Access Report

Lochinvar Shopping Village
Cnr Springfield Drive &
Robert Road
LOCHINVAR NSW

For: GWH
Ref: LP_22366

Development application documentation for the Lochinvar Shopping Village located at cnr Springfield Avenue and Robert Road Lochinvar, has been reviewed against current accessibility legislation.

Figure 2 | Overall Site Plan

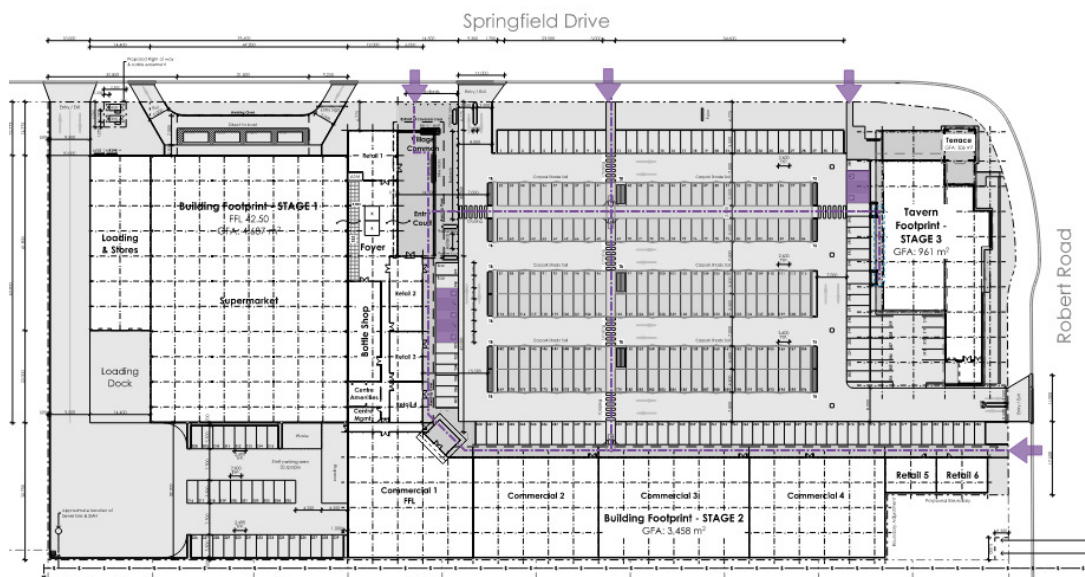
An accessible path of travel is provided to the building entrance from the allotment boundary along Springfield Drive & Robert Road. Level access is achievable.

An accessible path of travel is provided from accessible carparking spaces to the building entrances. Level access is achievable.

Formed pedestrian areas provide access throughout the site and to each building entrance. Level access is achievable.

On-grade carparking provides a total of three-hundred and thirteen (313) carparking spaces that includes thirty-two (32) staff carparks and five (5) accessible car parking spaces.

The overall configuration of the accessible carparking achieves compliance with current legislation including dimensions of the spaces and associated shared areas, chevron markings and provision of a bollard.

Kerb ramps provide access throughout the car parking area. The overall configuration is in keeping with current accessibility requirements.

Kerb ramps, aligned across the roadway, are provided at some pedestrian crossings. Where they are not provided, tactile indicator will be required and should be addressed as part of the detailed design.

Automatic sliding doors are provided for entrance to the Supermarket Foyer and Tavern. The use of this type of door is encouraged as it maximizes access for persons with a disability to the tenancy.

Double hinged doorways are provided to other tenancies. Adequate circulation areas are provided and a level threshold is achievable in each location.
